SHIELDALLOY METALLURGICAL CORPORATION

Re: Follow-up to the March 9, 2006 Meeting and Response to USNRC Letter of January 26, 2006

ATTACHMENT I
SMC Response to the USNRC's letter of January 26, 2006

FIGURE 2:
Radionuclides in Leachate Reaching the Water Table
RESRAD Model

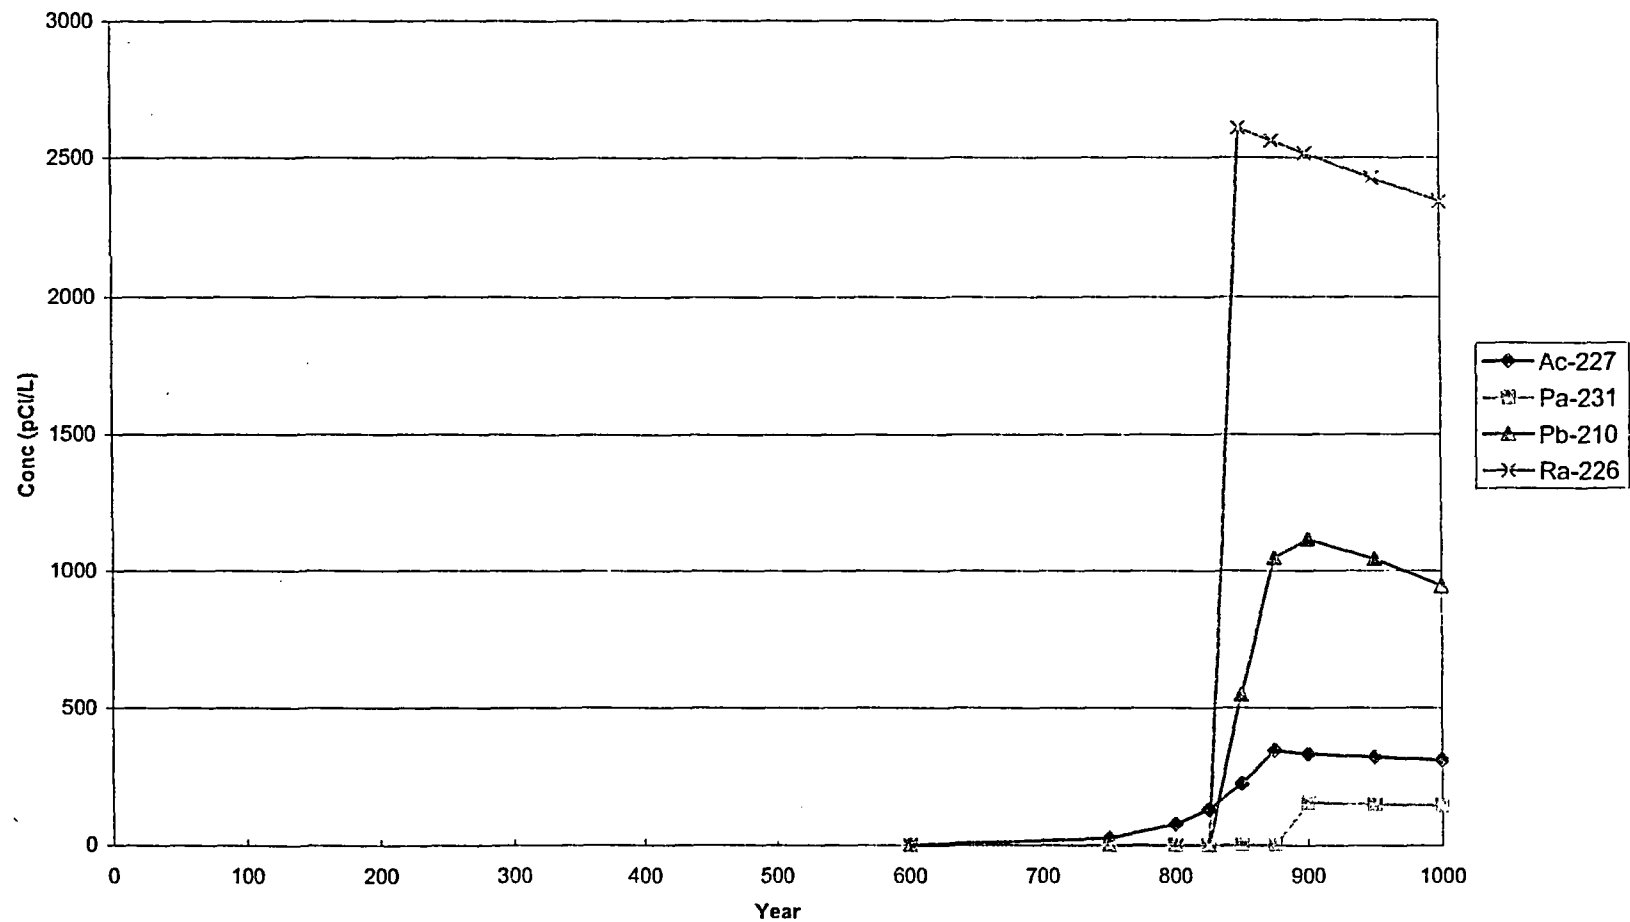
USNRC Issue No. 5: During a June 14, 2005 telephone conference, NRC staff advised SMC to evaluate the potential impacts associated with including the groundwater pathway before attempting to justify its exclusion. This comment was also reiterated in our June 24, 2005, letter to SMC (ML051680544). It is not clear if this was done in the DP.

After the model calibration was completed, a predictive solute transport simulation was conducted. This predictive simulation consisted of applying the RESRAD transient concentrations presented in Figure 2 at the water table over the entire area underneath the consolidated residual radioactive materials at a leaching rate equal to 10.9 inch/year. Chain decay was not explicitly simulated because the effect of the progeny was considered negligible. Transport of each radionuclide was evaluated independently. This simulation also included pumping from the hypothetical water supply well indicated in Figure 1. Table 1 presents the solute transport parameters used in this simulation.

FIGURE 18.8
ENGINEERED BARRIER
CONSTRUCTION DETAILS

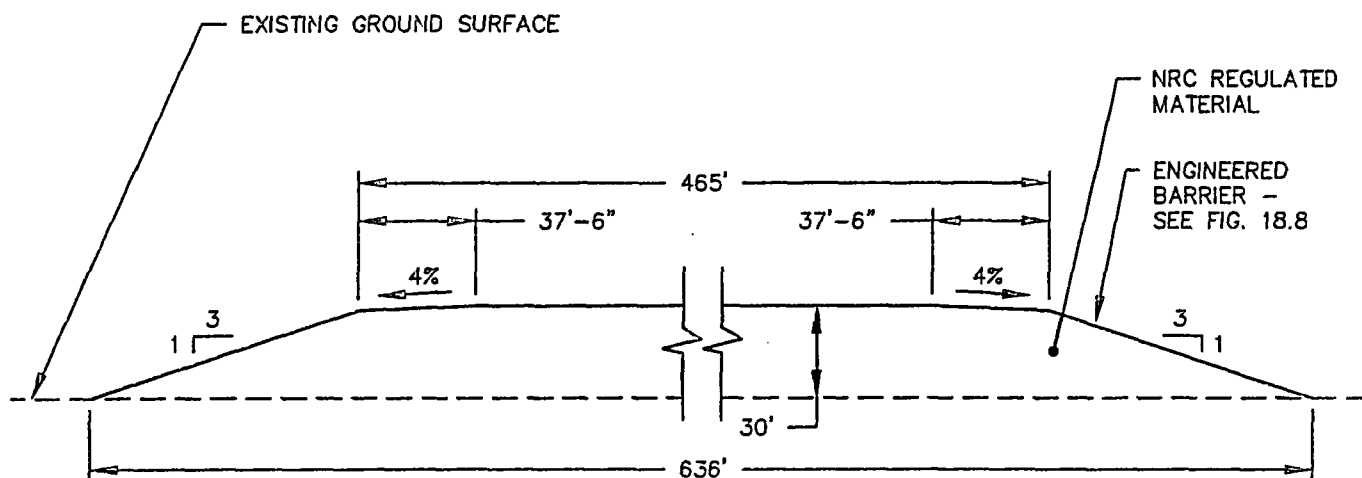
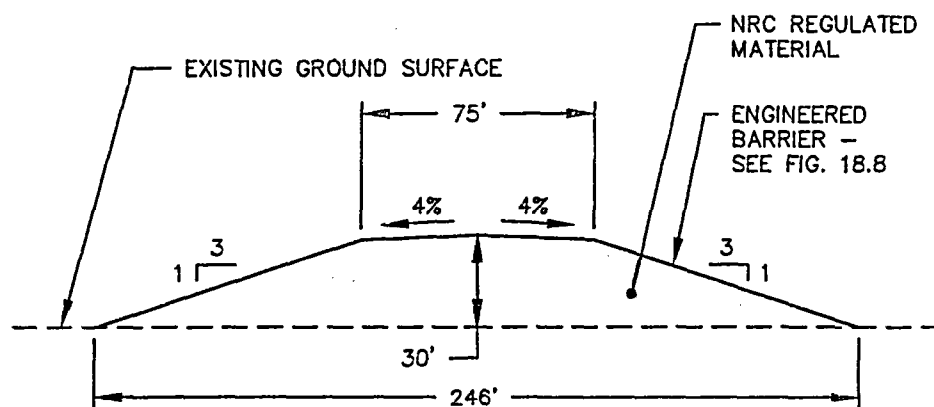
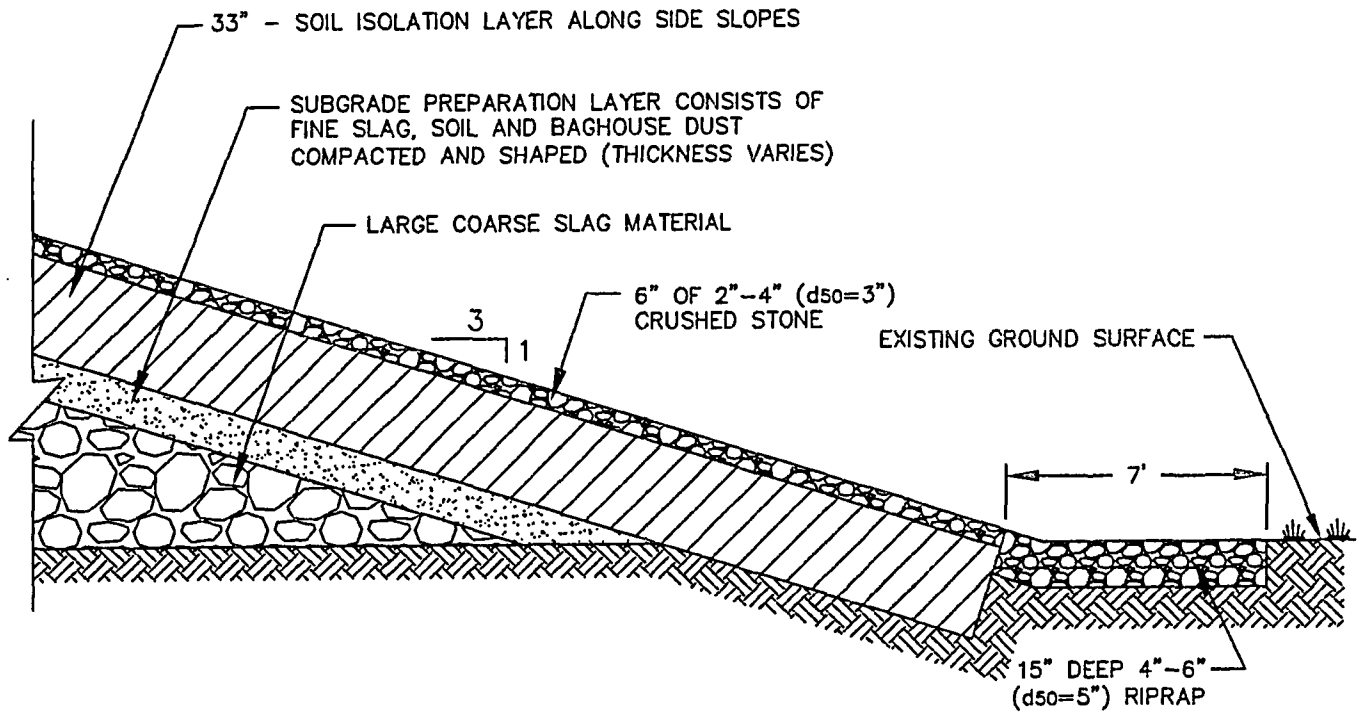
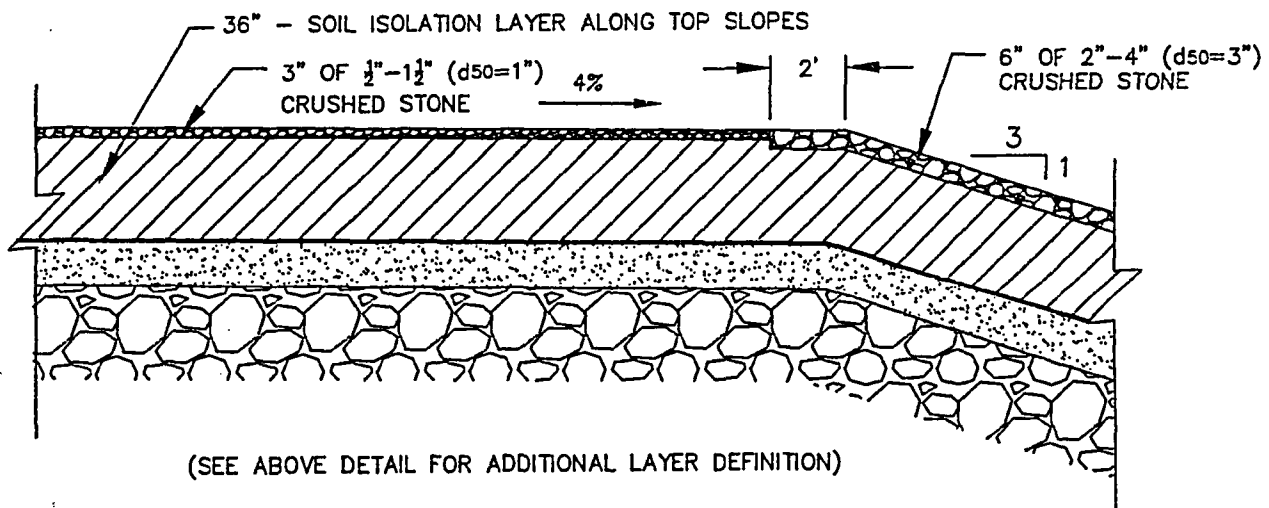
USNRC Issue No. 13: Major areas with either missing or insufficient information include: (4) Demonstration that the engineered cap has been designed to be sufficiently robust to remain effective even assuming loss of monitoring and maintenance (interim guidance, p. 11) (see also comment above on erosion control).

Figures 18.6, 18.7, 18.8 and 18.9 also required revision to reflect the new engineered barrier design. Appendix G of this document contains the revised figures. Figures 18.6 through 18.9 that currently exist in all USNRC copies of the DP should be removed and replaced with the figures in Appendix G in order to upgrade them to Rev. 1a.

Action to be Taken: See actions to be taken with respect to Issues No. 7 and 8. With the incorporation of a new engineered barrier design that includes the placement of rock on the top and side slopes as well as the toe of the side slopes, the accompanying engineering evaluations conducted in accordance with NUREG-1623 guidance demonstrate the protectiveness of these features, even without continued monitoring and maintenance. These revised evaluations clearly demonstrate the robustness of the engineered barrier.
